Access Compliance Report Public Rights-of-Way (Curb Ramps)

Main Street: CHAPMAN_AVE Cross Street: RANCHO_SANTIAGO_BLVD Location: SW

ADA ID: RPAT210929125633 Ramp Type: Type 7 - Directional 2 Initial Pass/Fail: Pass Overall Compliance: No Severity Score: 9

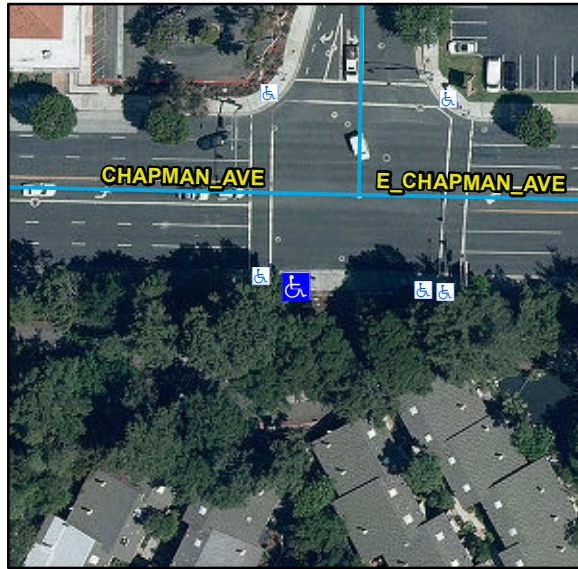
R304.2.1, R304.5.4, R304.5.3, STD 1115

Compliance	Description	Data	Compliance	Description	Data
N/A	Ramp Length (in)	101	Yes	Flare Type LT	Curbed2
Yes	Ramp Width (in)	79			
Yes	Ramp Run Slope (%)	7.4	N/A	Flare Slope LT (%)	N/A
Yes	Ramp Cross Slope (%)	0.7	N/A	Flare Traversable LT	N/A
Yes	Grade Break	Yes	N/A	Flare Type RT	
Yes	Grade Break Slope (%)	4.1			None
Yes	Grade Break Cross Slope (%)	2.2	N/A	Flare Slope RT (%)	N/A
	Addl Para Ramp Left?	No	N/A	Flare Traversable RT	N/A
	Addl Para Ramp Right?	No	Yes	DWS Provided	Yes
N/A	Landing Present	Yes	Yes	DWS Contrast	Yes
No	Landing Length (in)	42	Yes	DWS Length (in)	60
Yes	Landing Width (in)	85	Yes	DWS Full Width	Yes
Yes	Landing Run Slope (%)	0.1		DWS Offset Type	Multiple
Yes	Landing Cross Slope (%)	0.3	Yes	DWS Left Offset (in)	24
N/A	Landing Movement Obstructed?	No	Yes	DWS Right Offset (in)	0
	Landing Movement Type	N/A			
N/A	Landing Shared	No			
N/A	Marked Crosswalk 1	No	N/A	Clear Space	N/A
	Crossing 1 Direction	E	N/A	Clear Space To Crosswalk (in)	N/A

Marked Crosswalk 1 Width (in)	N/A			
N/A	Ramp Inside Crosswalk 1	N/A			
	Crossing 1 Slope (%)	0.7			
	Crossing 1 Cross Slope (%)	6.4			
Yes	Gutter Ponding	No	Yes	Curb Slope	0.5
Yes	Gutter Lip Height (in)	0		Road Run Slope (%)	N/A
No	Gutter Run Slope (%)	7.4		Road Cross Slope (%)	N/A
No	Gutter Cross Slope (%)	5.7		Parallel Ramp Side	Left
Yes	Overall Surface Condition	Acceptable	Yes	Perp Joint Present	Yes
	Cross Gutter Present?	Yes		Spandrel Present?	Yes
	Replace Cross Gutter?	No		Replace Spandrel?	No

Remove & Replace Landing. Remove & Replace Gutter. Utility Present.
